# UNITED STATES PATENT AND TRADEMARK OFFICE

APPLICATION NO.	FILING DATE	FIRST NAMED INVENTOR	ATTORNEY DOCKET NO.	CONFIRMATION NO.
10/606,479	06/26/2003	Robert J. Smith JR.	16930-1	5653
23486	7590	06/30/2004	EXAMINER	
SHUTTLEWORTH & INGERSOLL, P.L.C. 115 3RD STREET SE, SUITE 500 P.O. BOX 2107 CEDAR RAPIDS, IA 52406			MACARTHUR, VICTOR L	
		ART UNIT	PAPER NUMBER	
		3679

<b>Office Action Summary</b>	<b>Application No.</b>	<b>Applicant(s)</b>
	10/606,479	SMITH ET AL. <i>CS</i>
	<b>Examiner</b>	<b>Art Unit</b>
	Victor MacArthur	3679

Marked up Fig.1

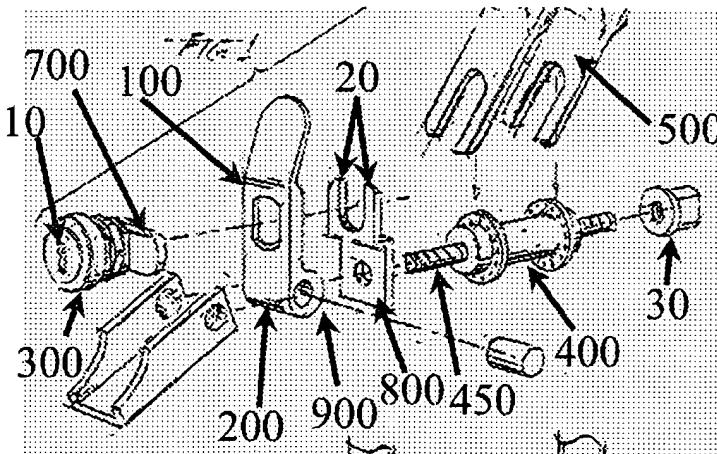
Claims 1-13, 15, 18, 19 and 21-23 are rejected under 35 U.S.C. 103(a) as being unpatentable over Katsouros U.S. Pub.20020026816 (see marked-up figures below) in view of Chang U.S. Patent 5479836.

Claim 1. Katsouros discloses a locking quick release device for lockingly affixing a removable component (500) to a fixed component (100, 200 and 400 are fixed to wheel 600), the fixed component having a first member (100, 200) and a second member (400) moveable toward and away from each other between a first position (as seen in fig.2) in which the removable component is affixed to the fixed component and a second position (seen in fig.3) in which the removable component is removable from the fixed component, said locking quick release device comprising: a lever (100, 200) having a handle end (100) and a pivot end (200), the lever being movable about the pivot end between an open position and a closed position so that movement of the lever to the closed position causes the members to move to the first position and movement of the lever to the open position causes the members to move to the second position; and a locking mechanism (300) operatively combined with the handle end of the lever to selectively prevent movement of the lever about its pivot end when the locking mechanism is actuated into a locked position. Katsouros discloses that the removable component is a set of bicycle forks (500). Katsouros does not disclose a seat post. Chang teaches (figs. 3-5, 8 and col.1-4) a removable component that is a bicycle seat assembly (B), and that a locking quick release device is attached to the bicycle seat assembly, for the purpose of securing a bicycle seat assembly against theft. Therefore, it would have been obvious to one with ordinary skill in the art at the time the invention was made to modify Katsouros to be used on a bicycle seat assembly, for the purpose of securing a bicycle seat assembly against theft.

The applicant argues that the prior art does not disclose the locking mechanism at the handle end of the lever. This is not persuasive. Katsouros discloses (as seen in the marked-up figures above) a lever (100, 200) with a pivot end (bottom half 200) and a handle end (top half 100) wherein a locking mechanism (300) is located at the handle end of the lever.

Marked-up Fig.2

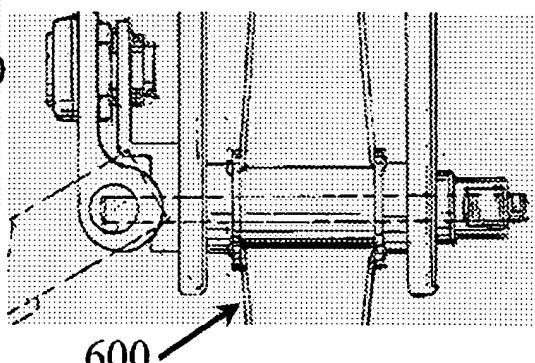
Claim 2. Katsouros as modified by Chang suggests that locking mechanism has a latching mechanism (700); and a receiving member (800) is combined with the fixed component for receiving the latching mechanism to provide for locking of the lever to the fixed component and thereby prevent removal of the bicycle seat assembly from the fixed component when the locking mechanism is actuated into a locked position.

Claim 6. Katsouros discloses wherein the lever further comprises a cam surface (900) near the lever pivot end so that movement of the lever to the closed position moves the first and second members to the first position in which they are closer together, and movement of the lever to the open position moves the first and second members to the second position in which they are farther apart.
